Access Compliance Report Public Rights-of-Way (Curb Ramps)

Main Street: O_NEILL_DR		Cross Street: SIENNA_PKWY		Location:	SE
ADA ID: RPRK211111125437	Ramp Type: Type 1 - Perpendicular	Initial Pass/Fail: Fail	Overall Compliance: No	Severity Score:	16
Codes/Mitigation Info/Possible Solution			Field Measurements/Component Compliance

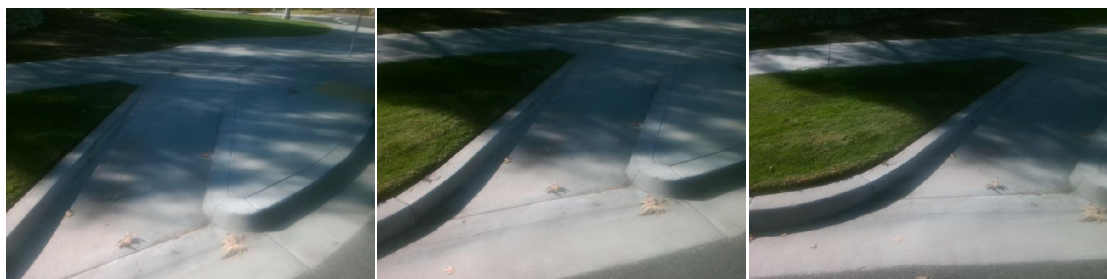
R204.3, R304.2.2, R304.5.3, STD 1115

Remove & Replace Entire Ramp.
